SUBJECT: JULINGTON CREEK ROAD BRIDGE APPROACH SLAB REPAIRS

BID #: CP-0171-22 **OPEN DATE:** 10/26/2022

SUBJECT: Change Order 1 BID CP-0171-22 / Contract 70130-23 / PO 652628-23
Hager Construction Company
Julington Creek Bridge Approach Slabs

CITY OF JACKSONVILLE
DEPARTMENT OF PUBLIC WORKS
ENGINEERING DIVISION
CONSTRUCTION CHANGE ORDER

NW

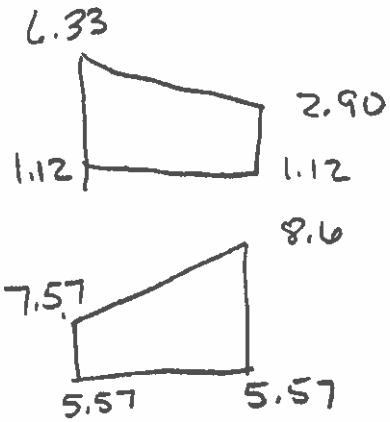
$$\frac{5.21 + 1.78}{2} \times 10 = 3.5 \times 10$$

$$\frac{2 + 3.03}{2} \times 10 = 2.52 \times 10$$

136' LF LONG

$30.08 \times 136 =$

$$\frac{4090.20}{27}$$

151.49 CY

TOTAL 370.78 CY

MINUS 109 CY GW

130.78 ENG EST FILL DIRT

West Approach slab STA 12+32.56 => 12+52.36

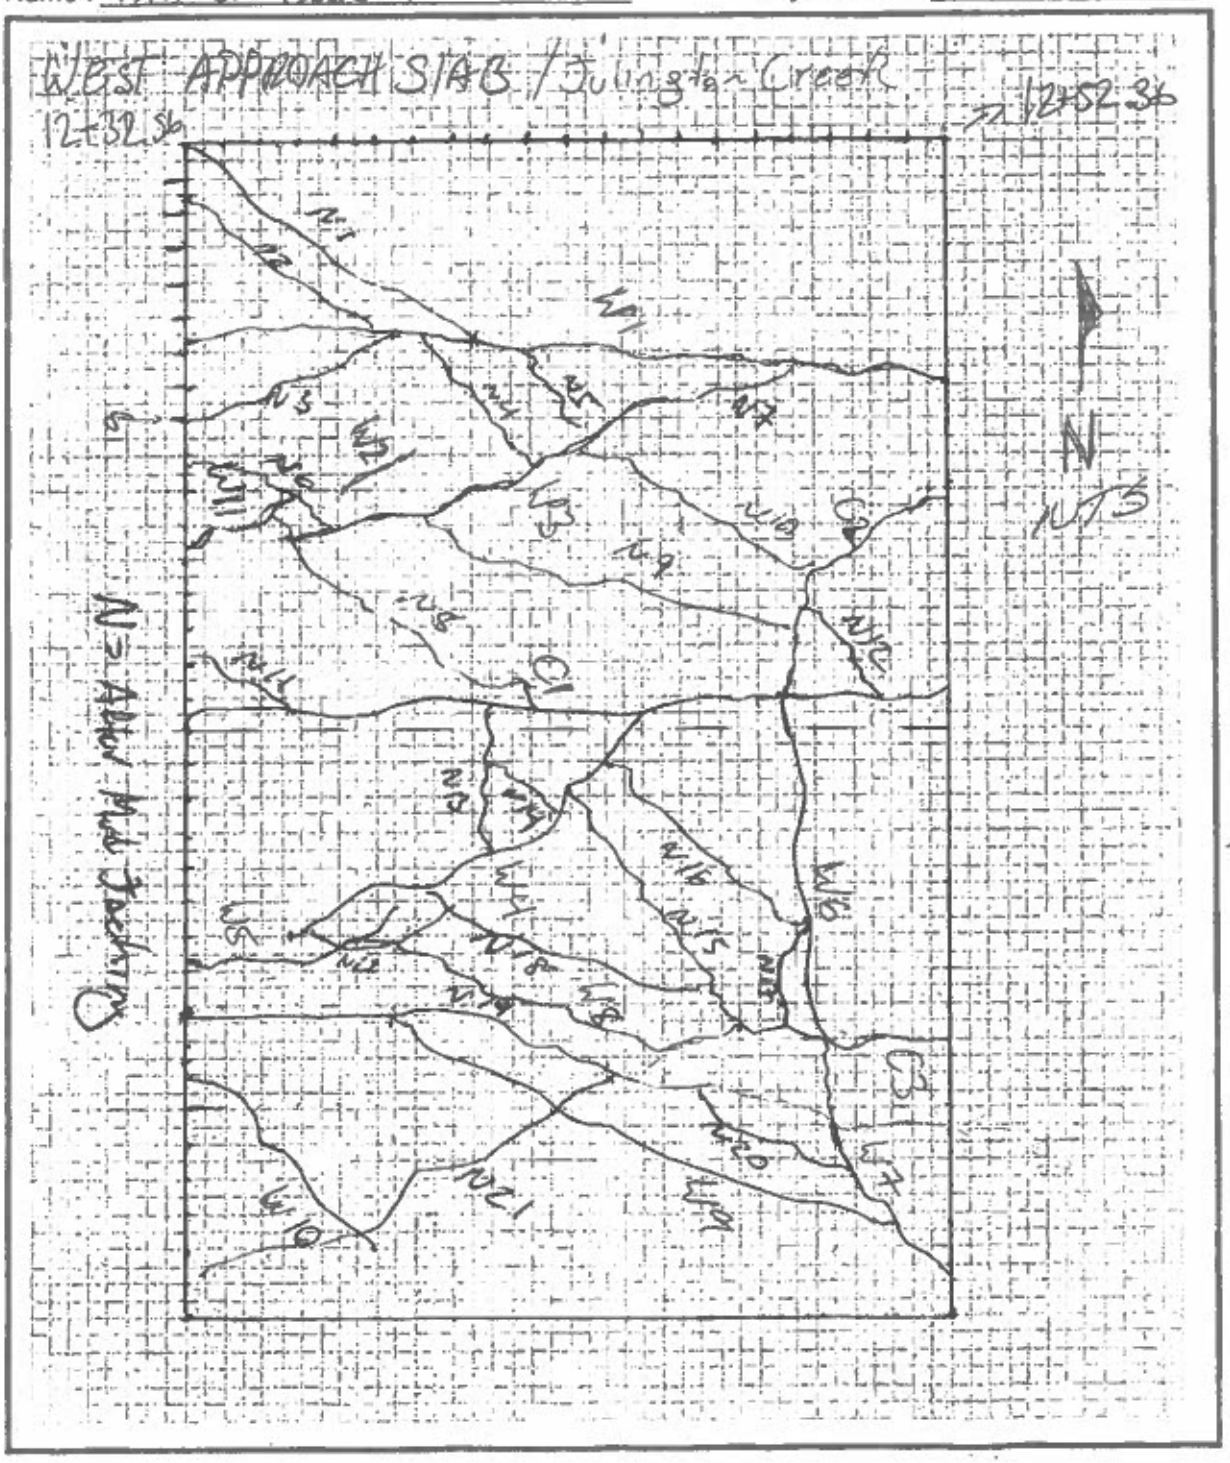
Crack Number	Deck Width (Note Location of Width Change)	Begin Location UP/DN Station From X	Begin Inside Face LT/RT Traffic Rail Y	End Location UP/DN Station To X	End Inside Face LT/RT Traffic Rail Y	Crack Width Measured at 3 Locations (in)		
N8	37'	12+34	10.6'	12+40.5	16.6'	0.007	0.016	0.010
N9		12+36.6	10'	12+48.5	15.6'	0.012	0.012	0.008
N10		12+43.6	7.75'	12+50.3	12'	0.006	0.006	0.006
N11		12+32.56	15.6'	12+35.5	16.75'	0.008	0.008	0.006
N12		12+48.6	15.25'	12+50.9	16.6'	0.012	0.010	0.010
N13		12+39.8	16.6'	12+39.4	21'	0.007	0.007	0.007
N14		12+39.6	17.5'	12+42	18.8'	0.008	0.008	0.008
N15		12+42.4	18.8'	12+46	25.75'	0.010	0.010	0.008
N16		12+44	17.3'	12+48	21.1'	0.008	0.008	0.008
N17		12+48.3	22'	12+48.1	25.6'	0.012	0.012	0.012
N18		12+37.8	21.6'	12+45.9	24.6'	0.008	0.008	0.010
N19		12+37	23'	12+46.9	26.1'	0.020	0.008	0.006
N22		12+35	28.5'	12+38	21.5'	0.014	0.010	0.010
N20		12+45.6	28.5'	12+47.7	30.4'	0.016	0.008	0.006

N21		12+32.56	35'	12+43.5	28.25'	0.016	0.014	0.014

N= After Mud Jacking

EAST APPROACH SIDE / Julington Creek

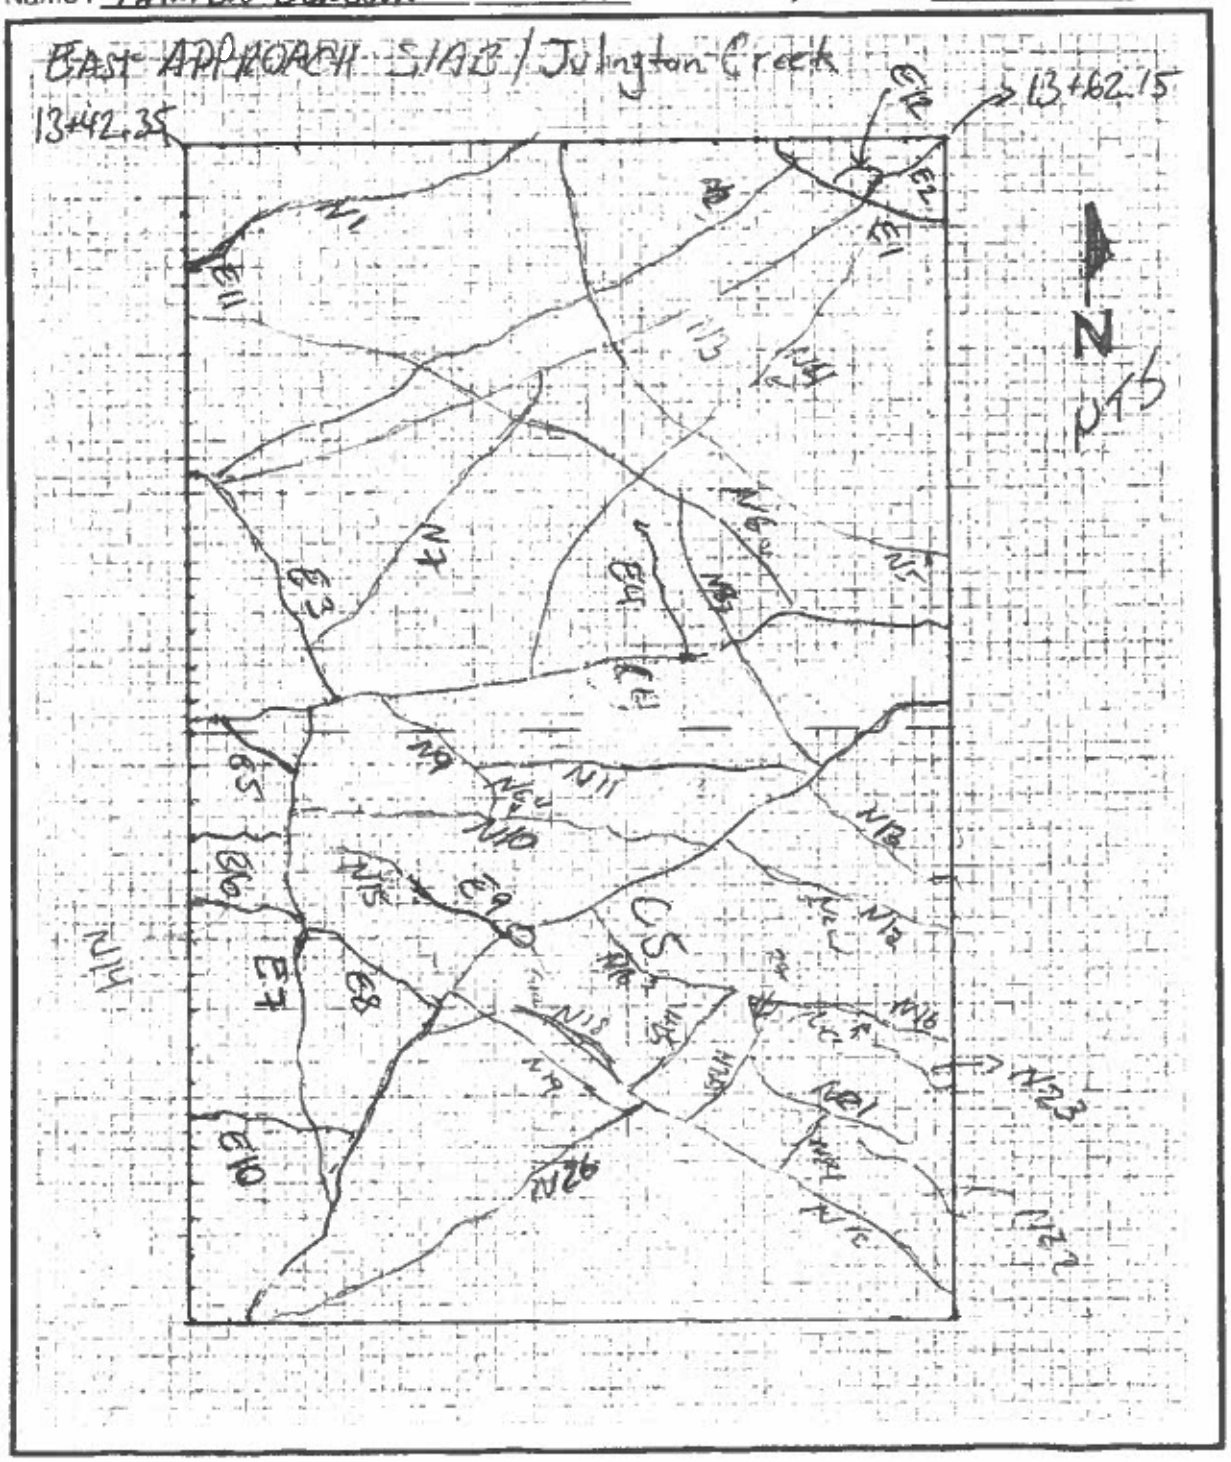
13+42.35

13+62.15

N = Attn Mud Jackins
